**LAT Engineering Meeting**

**LAT Integration Sequence Revision**

**Rev 3**

# Proposed Bay Integration Sequence (LAT bottom view)

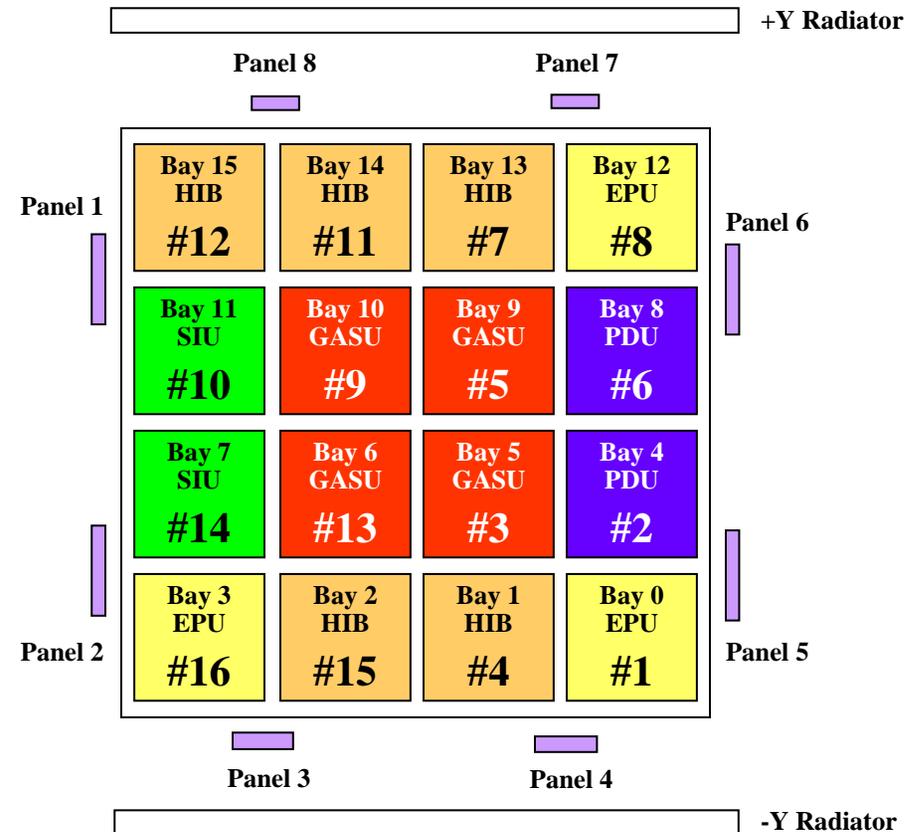
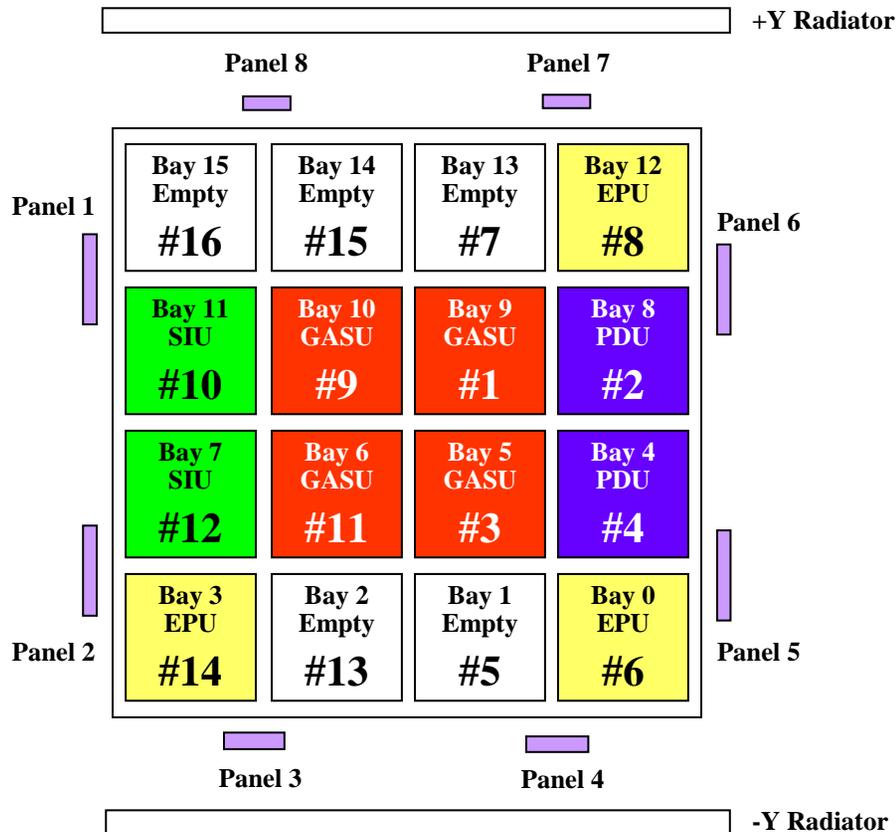
- ➔ R2 • \* **Preferred location for TKR-A to preserve sweet-spot for lower (perceived) risk modules**
  - The baseline integration sequence would have put TKR-A in one of the center bays

- Since TKR-A is perceived to have a higher risk of future module-level failure, it should not go in the center
  - ✓ Proposal: put TKR-A somewhere on the perimeter

- ✓ Proposal: with TKR-A going in bay 0 or 12 (on the  $-X$  side) leave the corresponding bays on the  $+X$  side of the LAT clear for as long as possible (thus, if TKR-A goes in bay 0, integrate bays 2, 3, 6, and 7 last). This leaves the cable trays adjoining the TKR-A bay less populated for longer so there is less impact on cable routing if TKR-A is removed

- Integrate bay 0 then 4
  - TKR-A goes in bay 0, TKR-B goes in bay 4
  - Use E-GSE cables and connector savers, with no cable trays
  - Run 2-tower CPT in this configuration, connecting to off-Grid E-GSE

- Then remove E-GSE cables from both towers
- Integrate bay 5 then 1
  - Integrate in bay 5, then connect flight TEM-GASU and TPS-PDU cables to bay 5 and 4 towers

- Integrate in bay 1, then connect flight cables to bay 1 and 0
  - This completes 4-5 and 0-1 pairs and LAT quadrant III (-X/-Y quadrant)
  - Install Shear Plates at 0-1-4-5 location and in bay 0 corner

- Integrate bay 9 then 8
  - EM-PDU can now stay in position for all future bay installs
  - Integrate cable trays in front of PDU to tie-off all remaining flight cables

- Integrate bay 13 then 12
  - Quadrant II (-X/+Y) and -X half of LAT is complete
- Integrate bay 10 then 11
- Integrate bay 14 then 15
  - This completes quadrant I (+X/+Y)

- All cables and cable ways on the +Y side of the LAT are installed
- Integrate bay 6 then 7
- Integrate bay 2 then 3
  - Integrate these bays last to minimize the cables running past bay 0
